## Manual addenda

## New functions

## Maintenance items

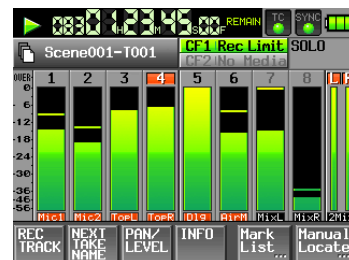
A limitation of this unit is that recording in a folder becomes impossible when the total number of files, subfolders and other items in that folder exceeds about 2000. For this reason, the following things might occur.

- If you press the **REC** key during recording, starting recording of the next take might not be possible. In this case, the following pop-up message appears.

- When a project or folder is loaded, recording to that folder might not be possible. In this case, the following pop-up message appears.

In addition, in these cases, **Rec Limit** appears as the remaining recording time for the currently selected CF card.
